SCHEDULE OF CHANGES

4. REMOVE THIS DRAWING FROM CURRENCY WHEN A REVISED DRAWING IS ISSUED.		
5. COPYRIGHT OF THIS DRAWING REMAINS WITH SCH ARCHITECTS.		
6. THIS DRAWING IS TO BE READ IN CONJUNCTION WITH THE EMPLOYER'S AND CONSULTANT'S PROJECT DOCUMENTS.		
A3		
C	27/09/22	SCHEDULE OF CHANGES ADDED
B	24/09/22	ROOF PLANT SCREEN ADDED
A	16/11/16	ISSUED FOR PLANNING
HA HODGES ARCHITECTS LTD T: 07932 376 008 E: MAIL@HODGESARCHITECTS.CO.UK W: WWW.HODGESARCHITECTS.CO.UK		
CLIENT		
HATTON GARDEN PROPERTIES LTD		
PROJECT		
72-80+82 LEATHER LANE LONDON, EC1N 7TR		
SCALE 1:50@A1 / 1:100@A3		DATE 11/05/22
DRAWN NH		CHKD SH

DRAWING TITLE		
PROPOSED NORTH ELEVATION		
PROJECT NO. 723	DRAWING NO. A119	REV. C

PROPOSED NORTH ELEVATION

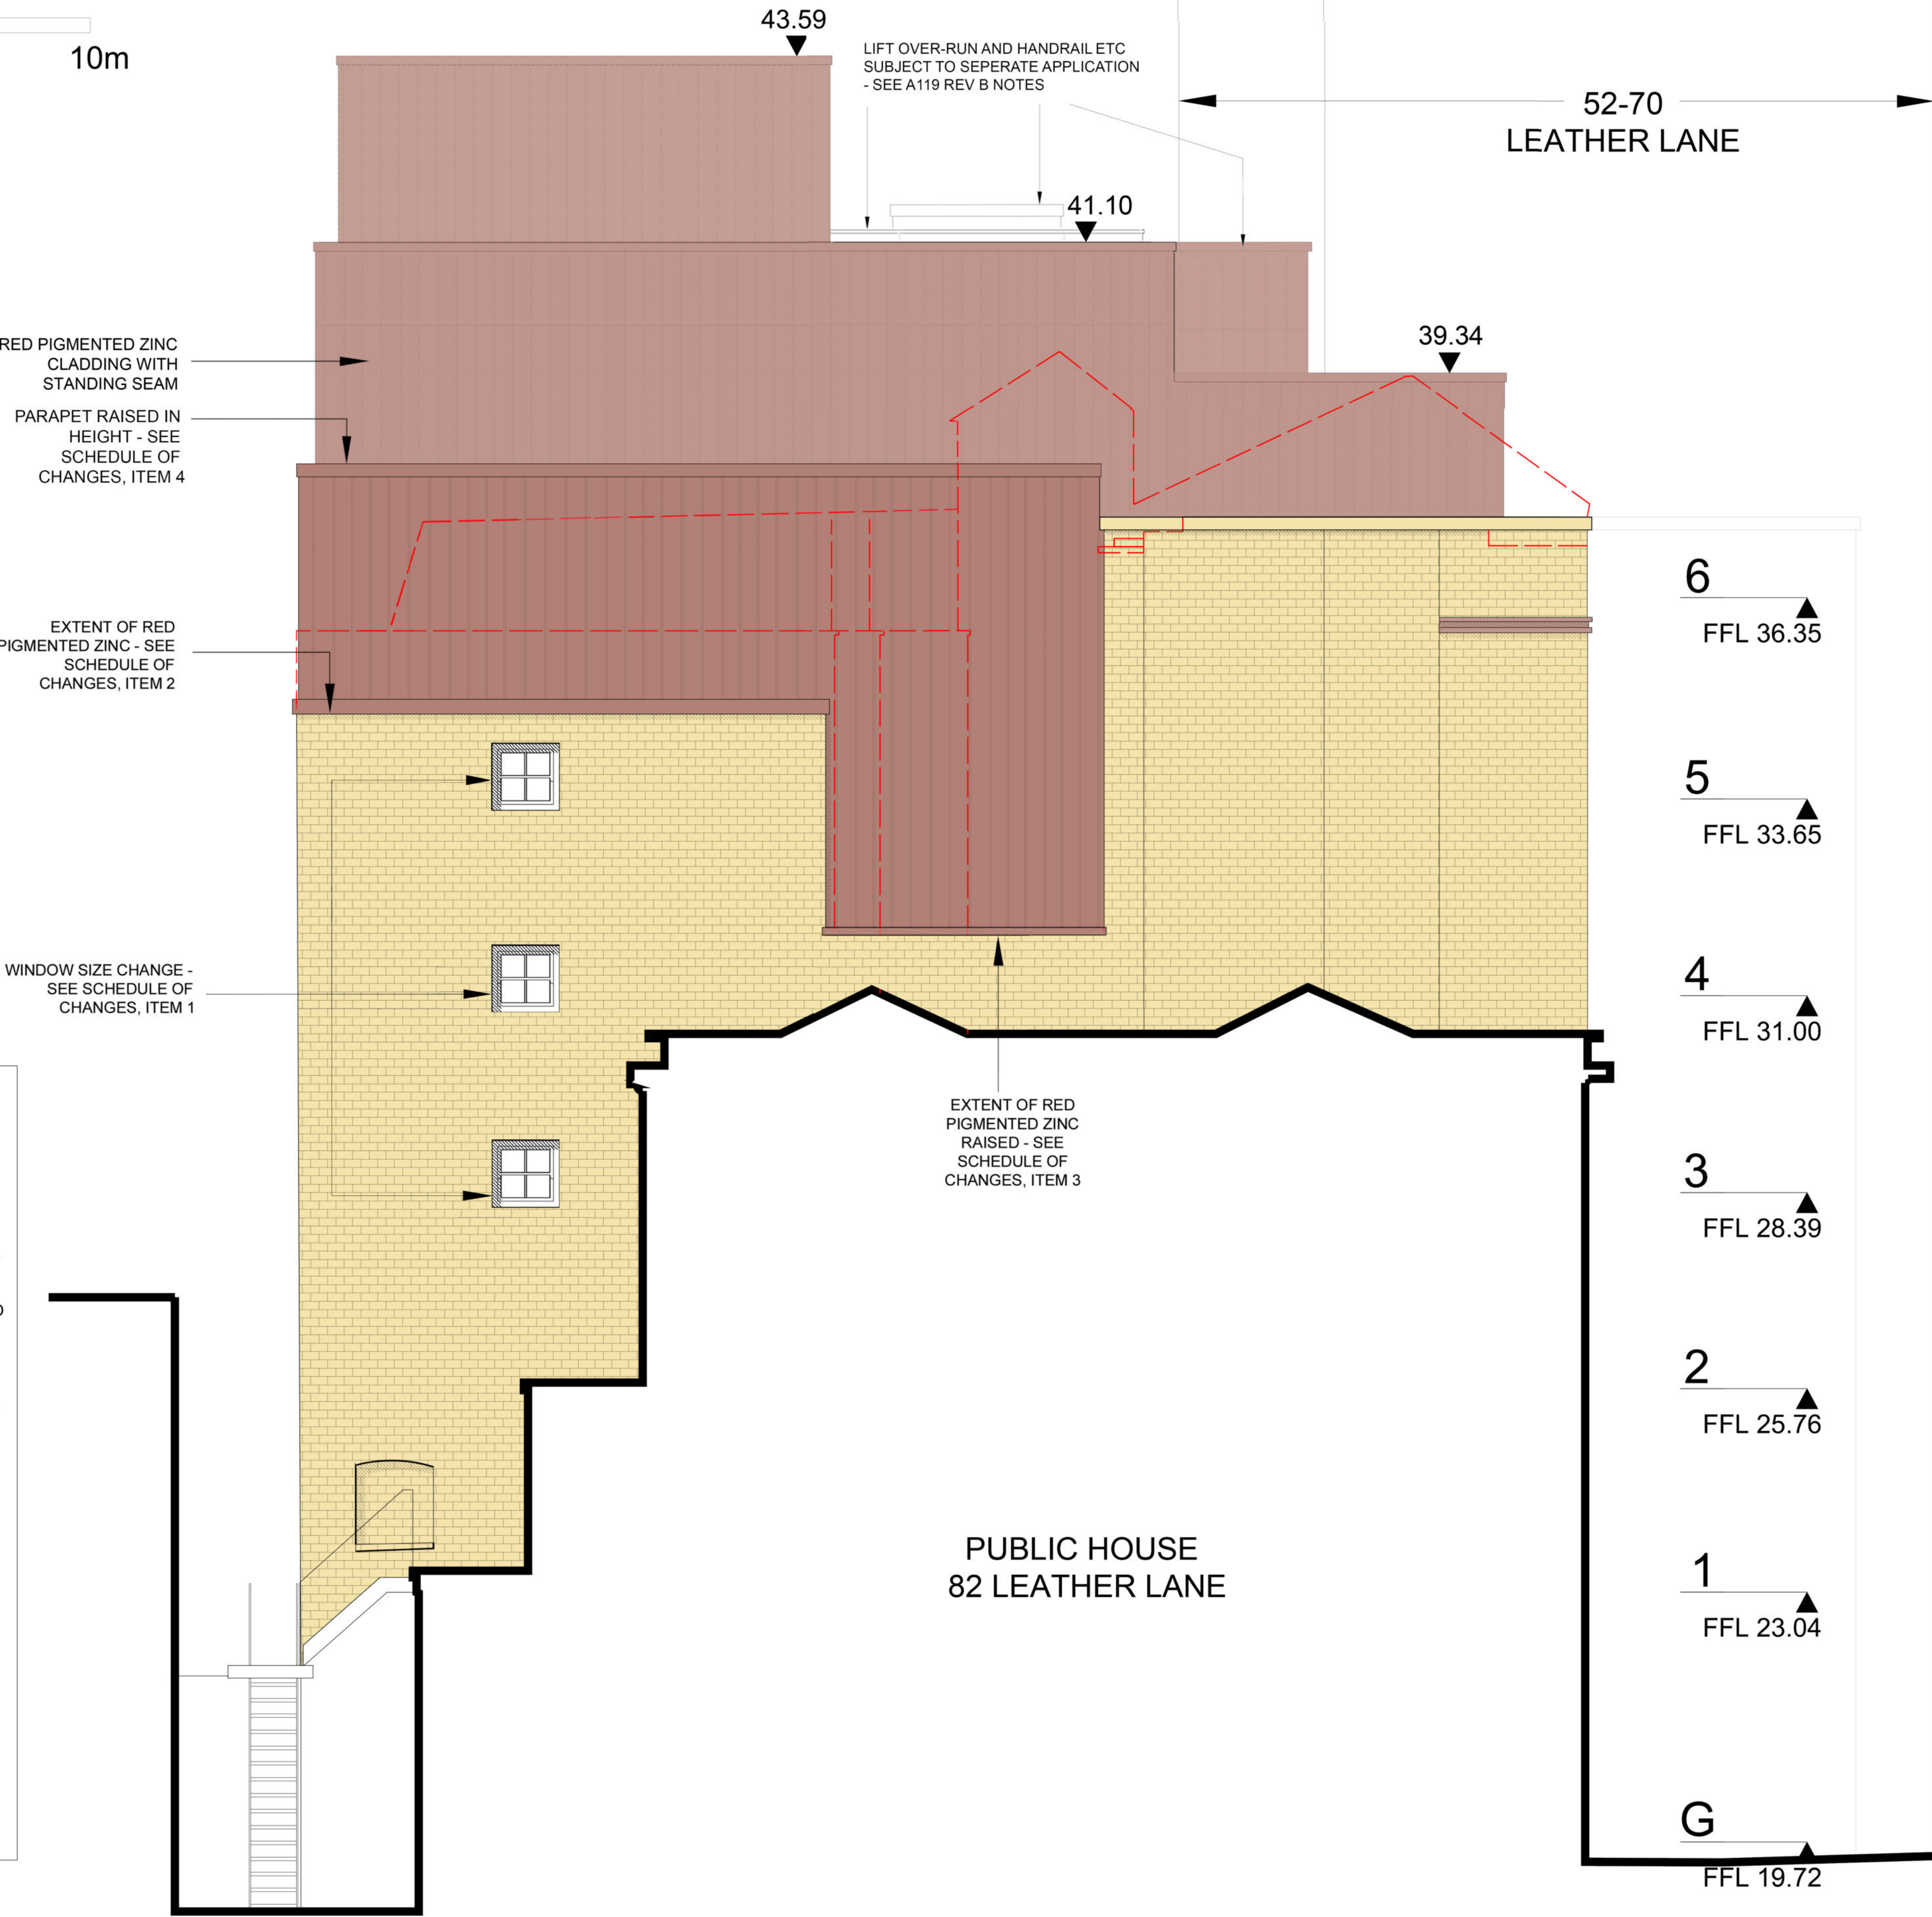
- ITEM 1**
3 No. WINDOWS REDUCED IN SIZE DUE TO INTERNAL STRENGTHENING REQUIRED TO THIS WALL
- ITEM 2**
EXTENT OF ZINC CLADDING LOWERED TO ALLOW FIXING OF CLADDING SUPPORT STRUCTURE TO STRUCTURAL STEELWORK EXISTING AT THIS LEVEL

- ITEM 3**
LOWER "SILL" OF ZINC CLADDING RAISED AND EXISTING BRICKWORK RETAINED TO AVOID DISTURBANCE OF EXISTING LEAD WORK WEATHERING TO PUBLIC HOUSE ROOF

- ITEM 4**
PARAPET RAISED IN HEIGHT DUE TO THICKNESS OF INSULATION REQUIRED TO ROOF BEHIND
- ITEM 5**
WINDOW TYPE REVISED TO DOUBLE CASEMENT COMPRISED OF AUTOMATICALLY OPENING BOTTOM HUNG WINDOW VENT AS REQUIRED TO PROVIDE 0.6M2 VENTILATION TO LFB REQUIREMENTS. SIDE HUNG CASEMENT TO PROVIDE TENANT OPERABLE OPENING VENT. WINDOW FRAME TYPE REMAINS THE SAME AS CONSENTED ALUMINIUM WINDOW SYSTEM

- ITEM 6**
SINGLE BOTTOM HUNG WINDOW TYPE TO PROVIDE AUTOMATICALLY OPENING WINDOW VENT AS REQUIRED TO PROVIDE 0.6M2 VENTILATION TO LFB REQUIREMENTS. ADJACENT SMALLER SIDE HUNG CASEMENT TO PROVIDE TENANT OPERABLE OPENING VENT. WINDOW FRAME TYPES REMAIN THE SAME AS CONSENTED ALUMINIUM WINDOW SYSTEM

- ITEM 7**
WINDOW POSITION RAISED UP WALL TO PROVIDE COMPLIANT INTERNAL WINDOW SILL HEIGHT
